CONNECTICUT SITING COUNCIL

RE: **DOCKET NO. 508** – The United Illuminating Company (UI) Certificate of Environmental Compatibility and Public Need for the Milvon to West River Railroad Transmission Line 115-kV Rebuild Project that consists of the relocation and rebuild of its existing 115-kilovolt (kV) electric transmission lines from the railroad catenary structures to new steel monopole structures and related modifications to facilitate interconnection of the rebuilt 115-kV electric transmission lines at UI's existing Milvon, Woodmont, Allings Crossing, Elmwest and West River substations along approximately 9.5 miles of the Connecticut Department of Transportation's Metro-North Railroad corridor traversing the municipalities of Milford, Orange, West Haven and New Haven, Connecticut. **Partial Development and Management Plan I Revision.**

Re: Docket No. 508 - The United Illuminating Company Application for a Certificate of Environmental Compatibility and Public Need for the Milvon to West River Railroad Transmission Line 115-kV Rebuild Project - Request for Modification to Structure Locations Near West River Substation

CROSS SECTION 13
ELMWEST SUBSTATION TO WEST RIVER SUBSTATION (WEST HAVEN):
STR P1034N AND STR P1038N

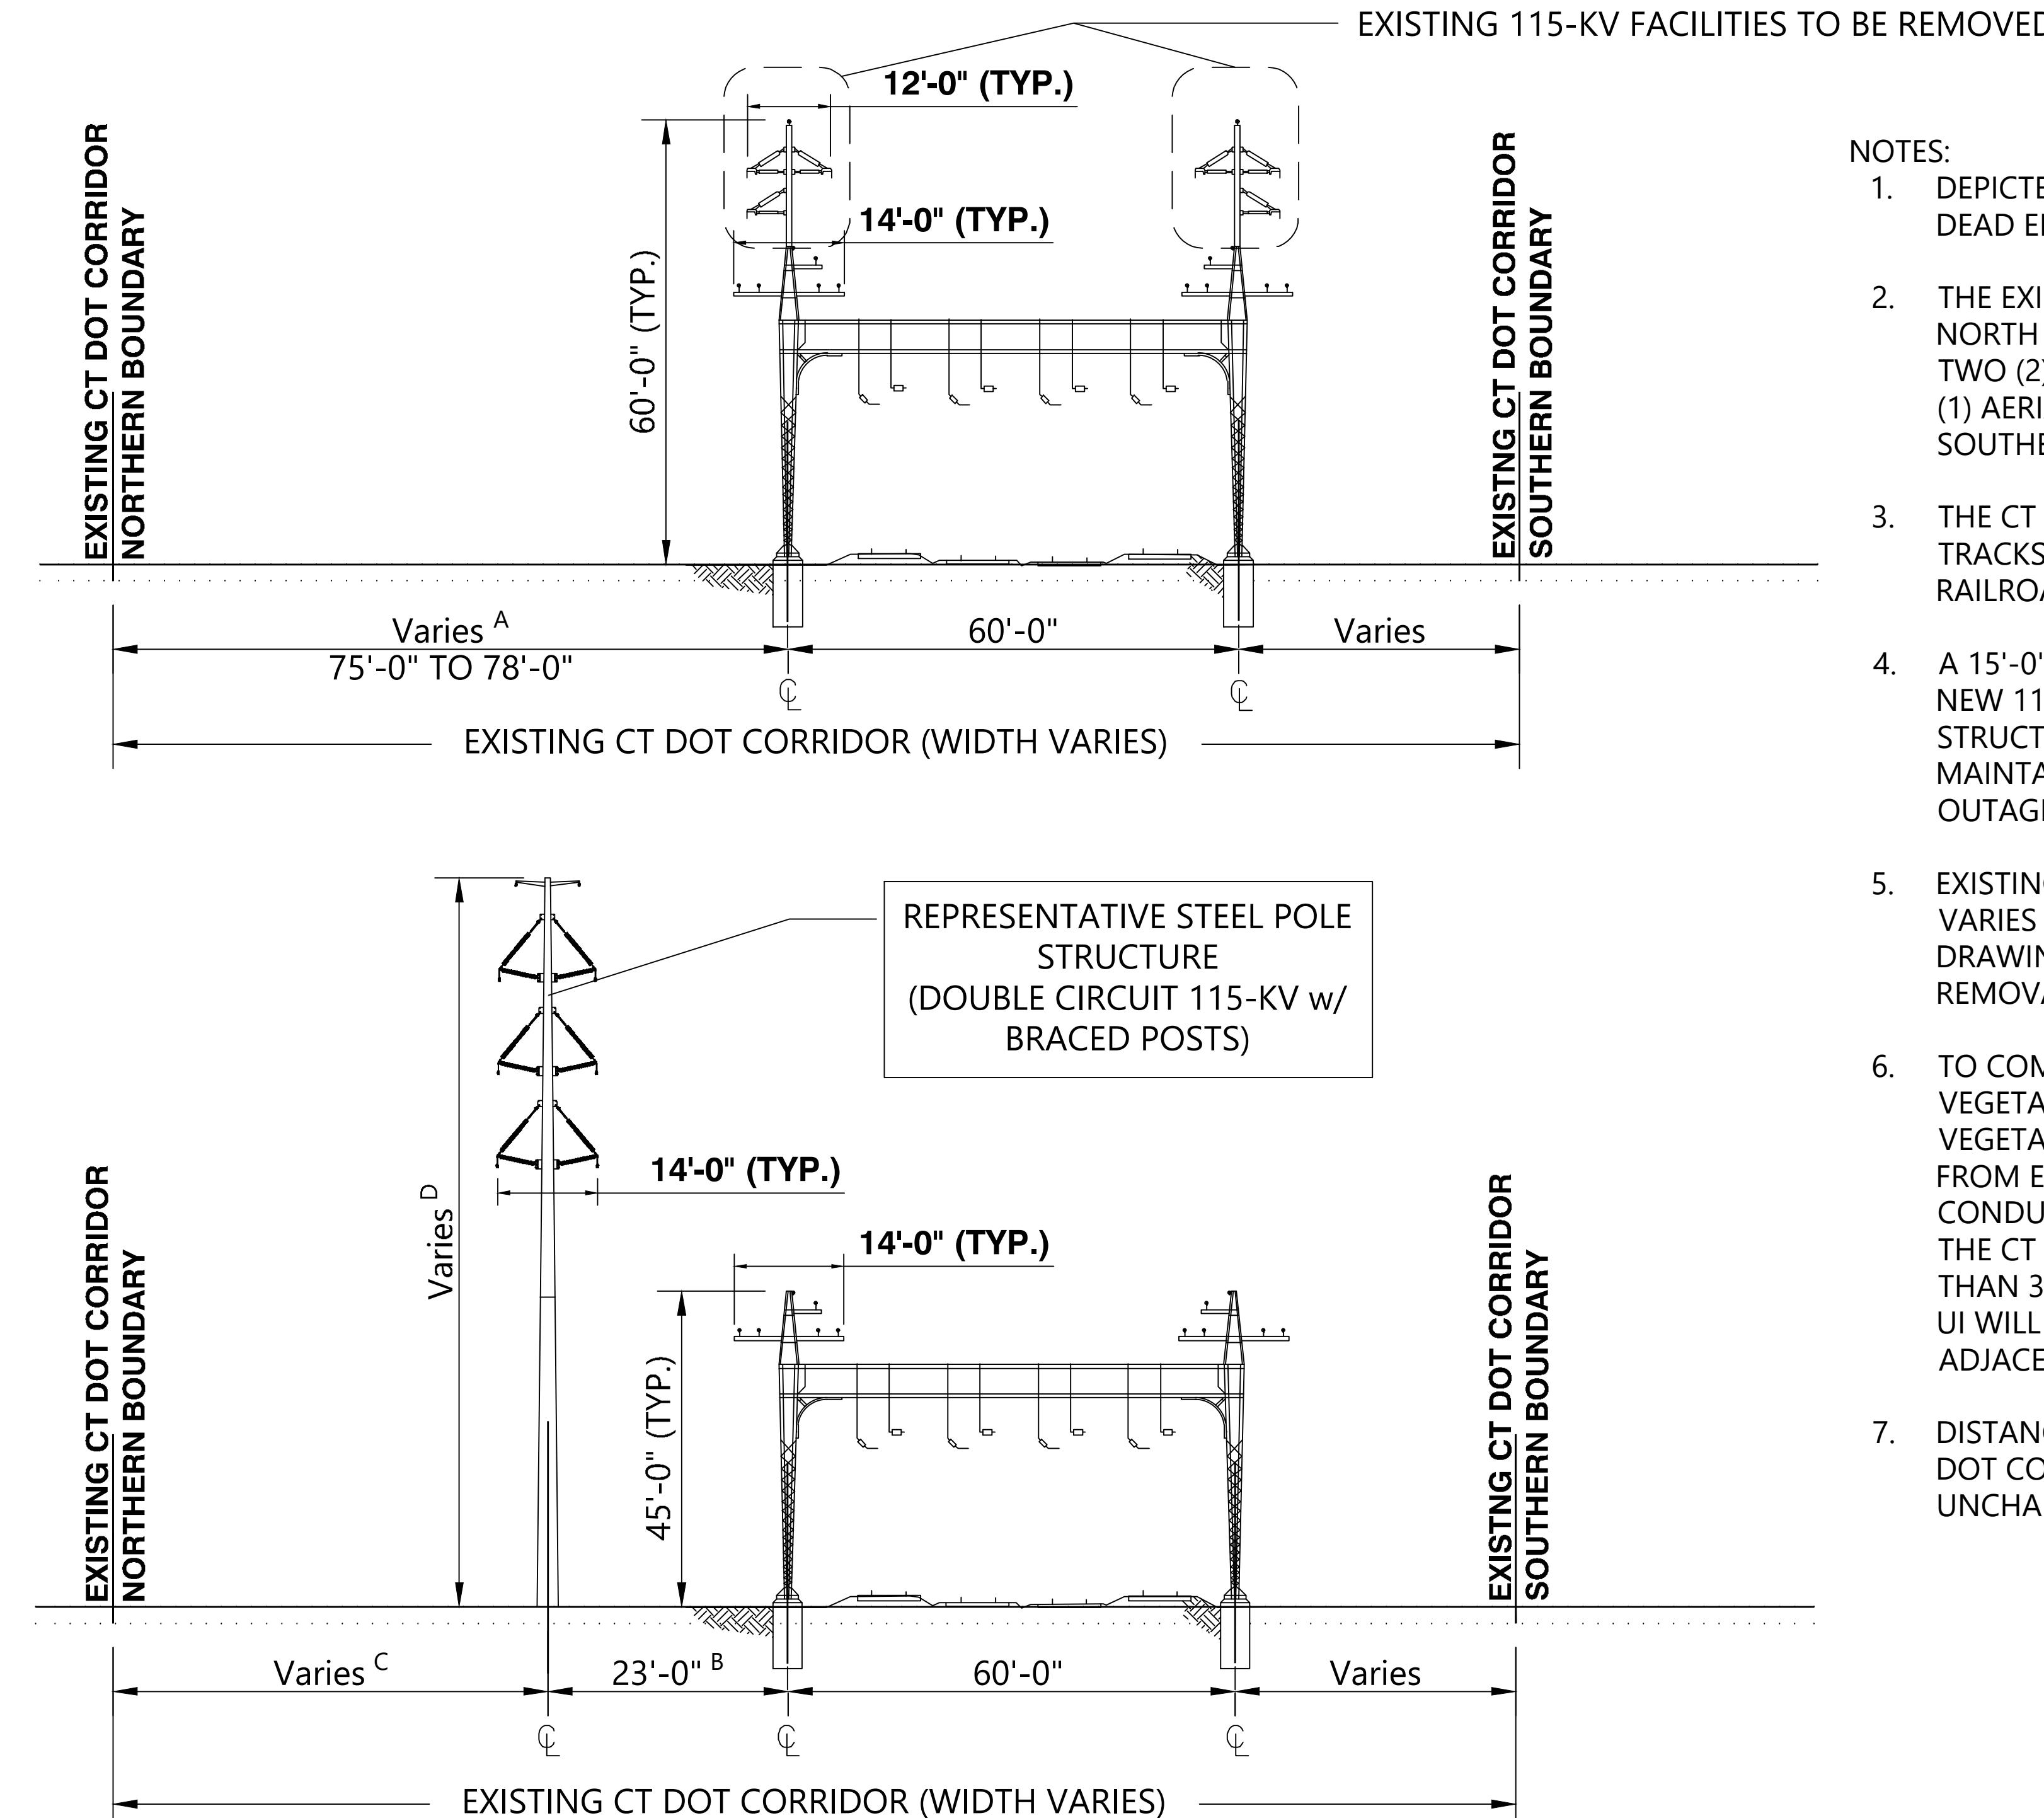
Structure No.	Pole Length (Original→Revised)	Structure Configuration (Original→Revised)	Transverse Offset* from Original Location (ft)***	Longitudinal Offset** from Original Location (ft)***
P1034N	100'→95'	Tangent w/ Braced Posts→ Deadend w/ Davit Arms	0	0
P1035N	95'→125'	Tangent w/ Braced Posts→ Tangent w/ Braced Posts	20	52
P1036N		Removed		
P1037N	95'→120'	Deadend w/ Davit Arms →Deadend w/ Davit Arms	47	33
P1038N	125'→125'	Tangent w/ Braced Posts→ Tangent w/ Braced Posts	0	35

- One of the double circuit steel monopoles originally planned for location along the north side of the MNR tracks in West Haven will be eliminated.
- Structures P1035N and P1037N will increase in height (to 120 and 125 feet, respectively) because of increased span length due to the elimination of P1036N and to maintain required vertical clearances for an adjacent building. These two structures were shifted farther north to accommodate the future planned spur tracks and work areas for MNR and CDOT.
- The realignment of P1035N and P1037N to the northern edge of the CDOT property will require easements on adjacent private properties, which will result in an additional 0.34 acre of permanent easements for the Project.

Structure	Cross Section #	Structure Height D (ft)	A (ft)	B (ft)	C (ft)
P1034N	13	95	78	26	52
P1038N	13	125	75	20	55

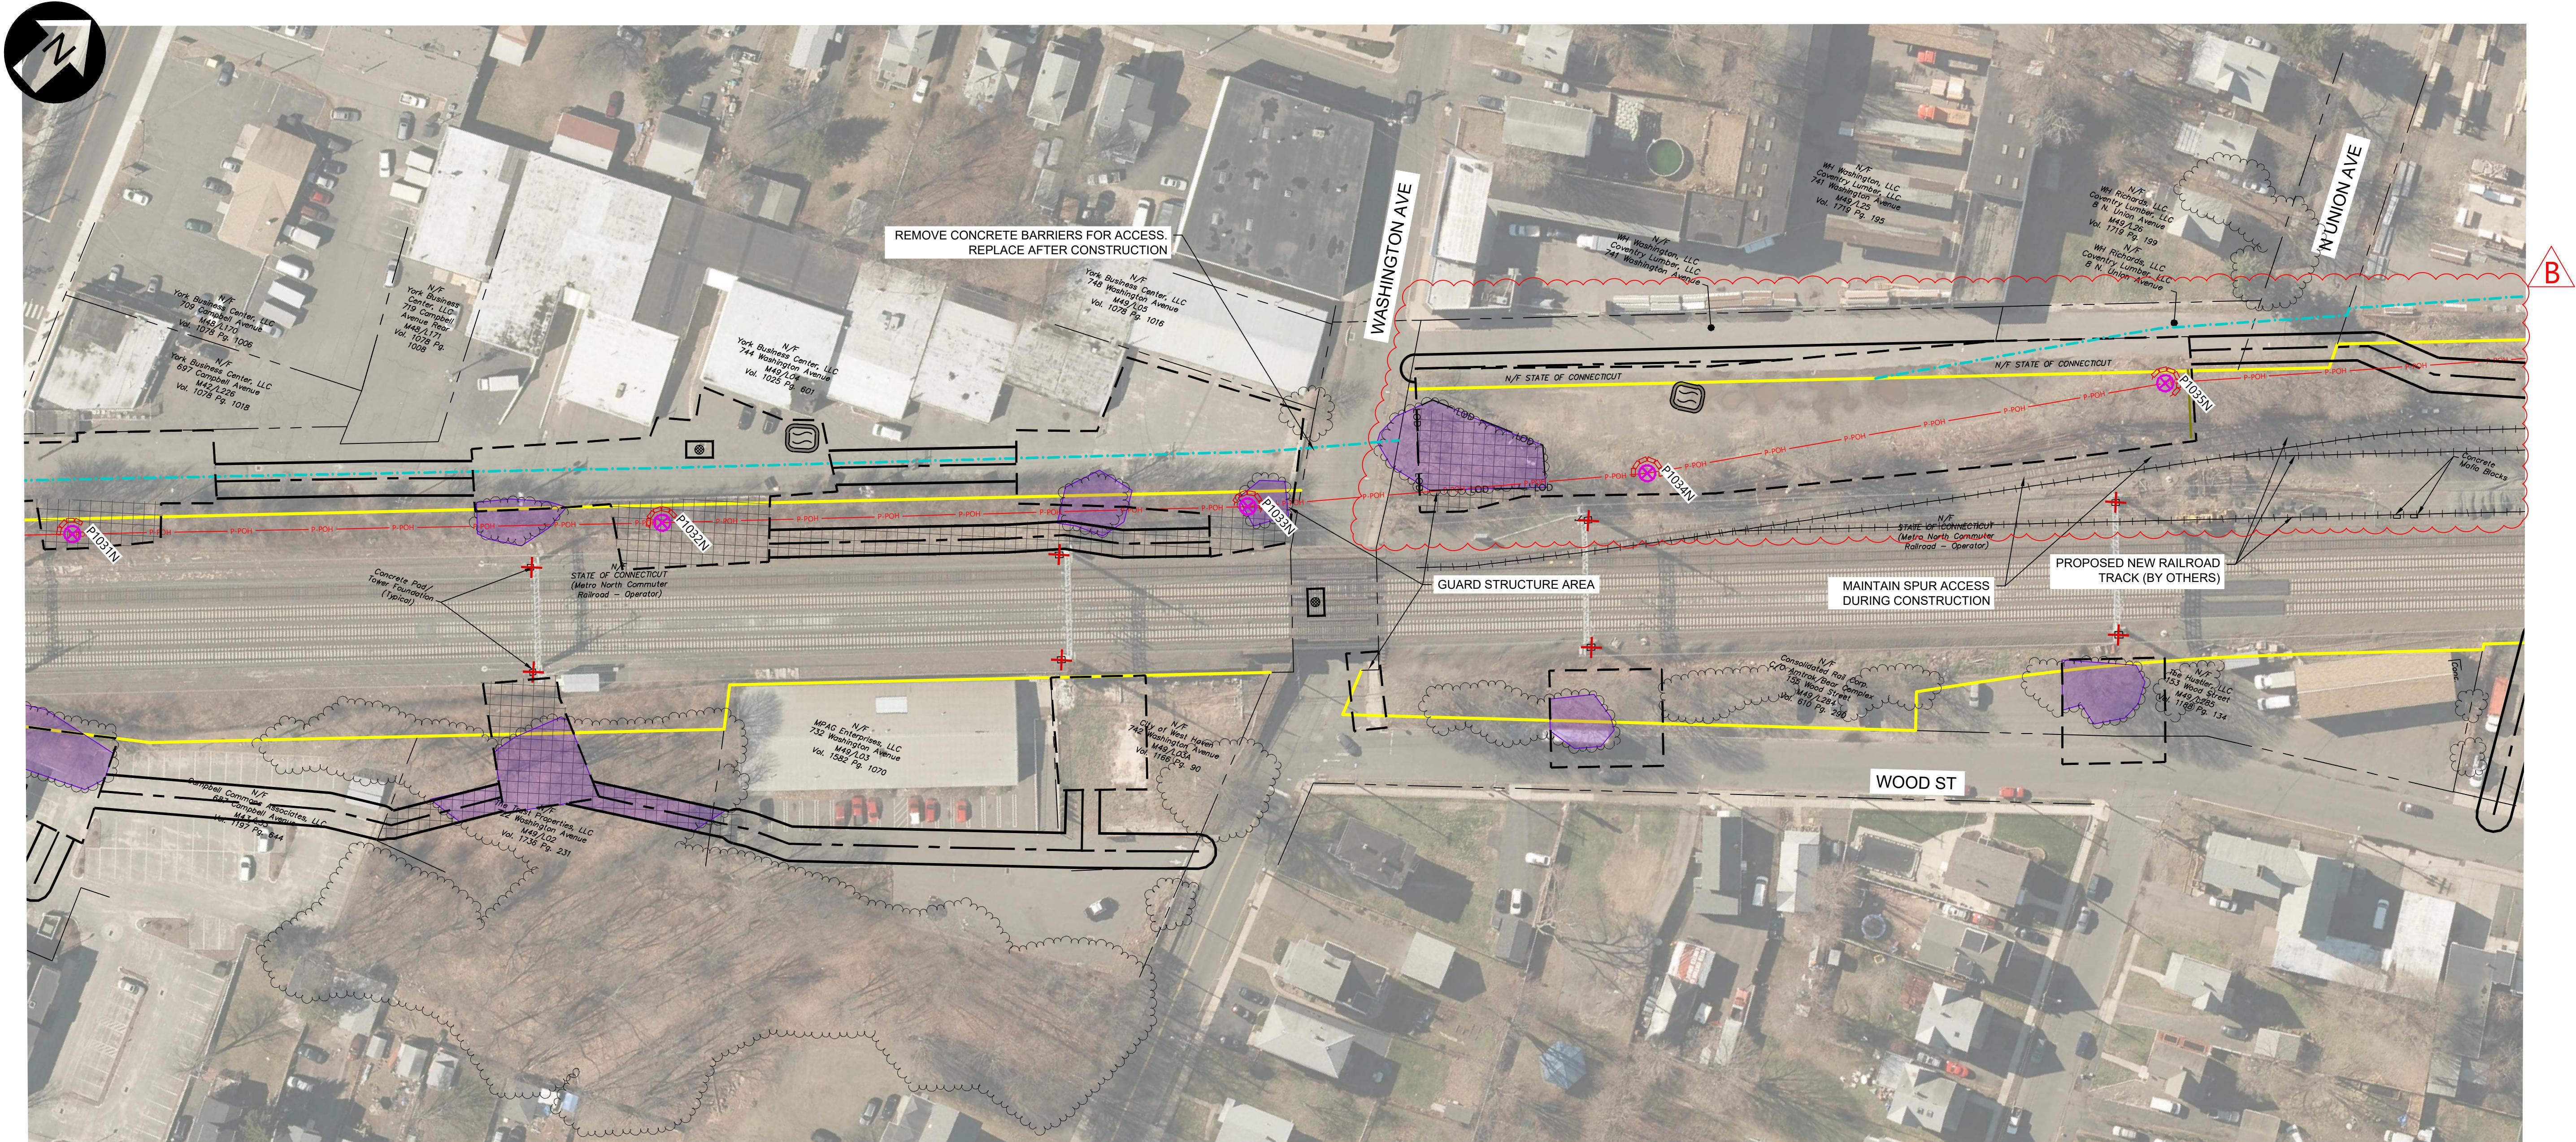
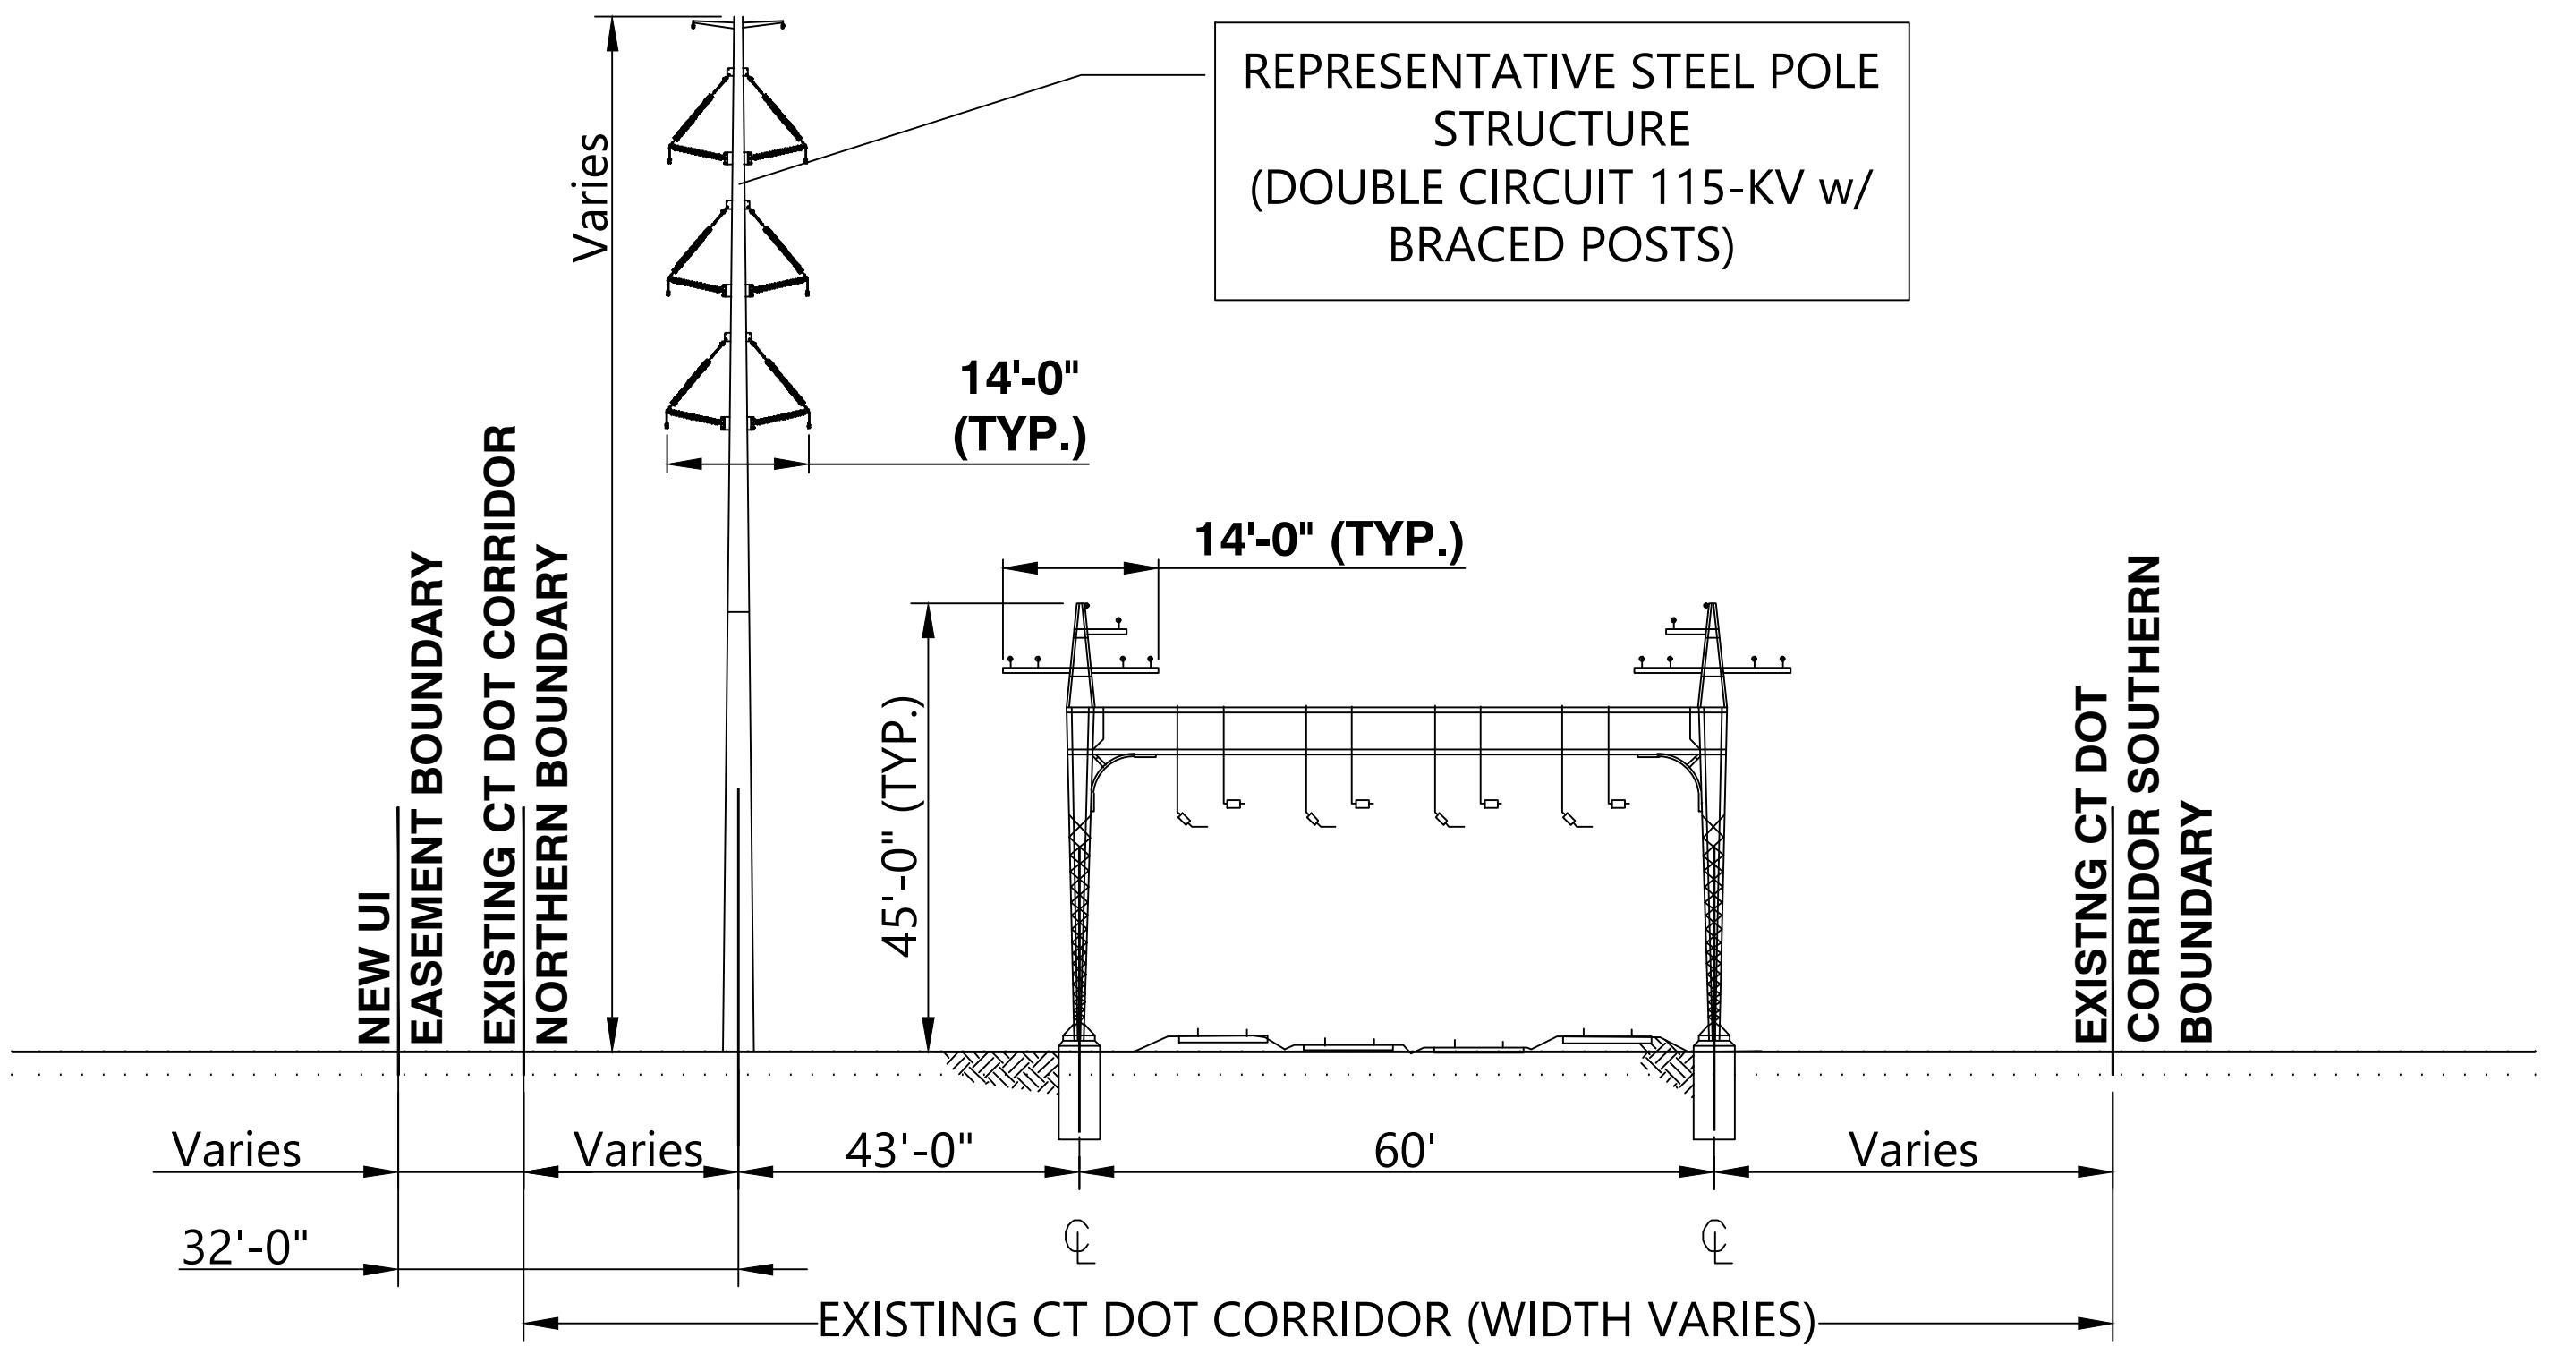
- a) Install a 95-foot deadend Structure P1034N in lieu of a 100-foot tangent structure, at the same location;
- b) Install a 125-foot tangent Structure P1035N in lieu of a similar 95-foot structure, approximately 20 feet in a traverse (northerly) direction and 52 feet in a longitudinal (easterly) direction of the original location;
- c) Eliminate Structure P1036N;
- d) Install a 120-foot deadend Structure P1037N in lieu of a similar 95-foot structure, approximately 47 feet in a traverse (northerly) direction and 33 feet in a longitudinal (easterly) direction of the original location; and
- e) Install a 125-foot tangent Structure P1038N in lieu of similar 125-foot structure, approximately 35 feet in a longitudinal (easterly) direction of the original location.

The Company received comments from the Connecticut Department of Transportation ("CDOT") on the positioning of transmission poles on CDOT property within CDOT's West Haven rail yard which is located north of the MetroNorth Railroad ("MNR") tracks (see Segment 1 D&M Plan, Volume 2, map sheets 2 and 3).¹ Based on those comments it was necessary for the Company to modify the location of the planned monopoles as follows:

STRUCTURE NO.	STRUCTURE TYPE	CROSS SECTION	HEIGHT (FT)	FOUNDATION
P1033N	TANGENT	XS-12	111	CONCRETE DRILLED PIER
P1034N	DEADEND	XS-13	96	CONCRETE DRILLED PIER
P1035N	TANGENT	XS-12	126	CONCRETE DRILLED PIER
